Virginia Department of Environmental Quality's investigation into the Mountain Valley Watch report titled "Mountain Valley Pipeline Stabilization, Pittsylvania County, VA"

March 17, 2020

Photo 1.  
MVW Photo Jan. 14, 2021 at MP 291 showing alleged inadequate vegetative stabilization.

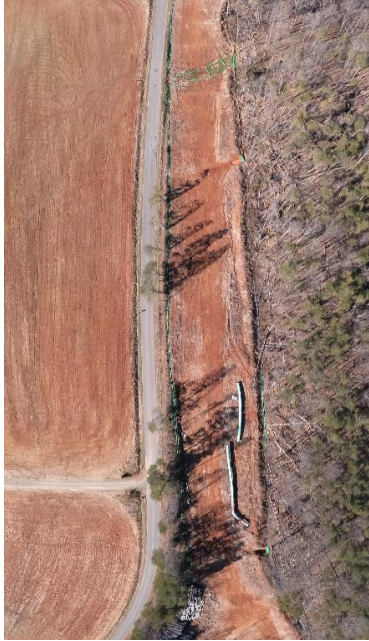
Inspected areas that were permanently stabilized had acceptable vegetative cover, being uniform, mature enough to survive and inhibiting erosion as required by Minimum Standard 1. (See Photo 6.) Areas that were temporarily stabilized had some vegetation in varying stages vigor and effectiveness in soil stabilization. Where temporary vegetation was observed to be in poor condition, soil stabilization was provided by straw mulch, blankets and matting, hydromulch or stabilization pellets. (See Photos 2., 4. & 8.) Inspectors observed that some of the temporary vegetation (annual grasses or grains) were in a mature or dormant condition and that straw in some areas had become stained by the underlying soil. This may be a reason why areas that were observed on the ground to be stabilized during the inspections appeared to have no cover in the aerial photographs in the MVW report. (See Photos 1. & 2.)

Photo 7.  
MV Photo Jan. 23, 2021 showing application of straw mulch over seeded area to maintain temporary stabilization.

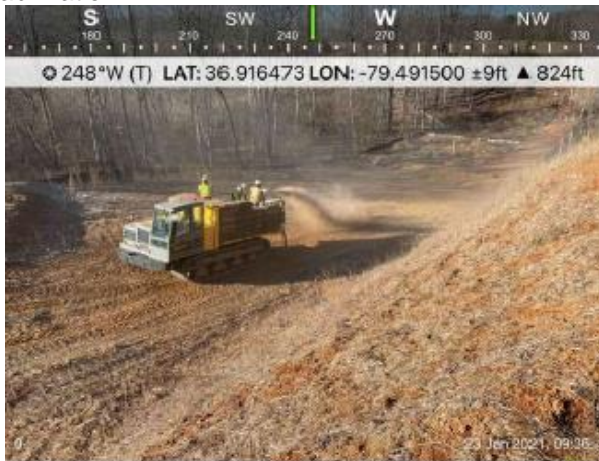
Even though the MVW report did not include observations of sediment being discharged from the right-of-way, DEQ treated it as a complaint and assigned an incident response number in its PReP database. This was done to investigate MVW's allegations of non-compliance and document the findings in this report. Upon DEQ's request, MVP produced records of its recent stabilization activities on spread I that show temporary seeding was applied in various areas in Pittsylvania from May 2020 through March 2021. On this project, temporary seeding is always applied with an additional soil stabilizing material, which may include straw mulch, erosion control blankets and matting, hydraulically applied bonded fiber matrix or biotic soil media and aerial or hand-applied stabilization pellets. (See Photo 7.)
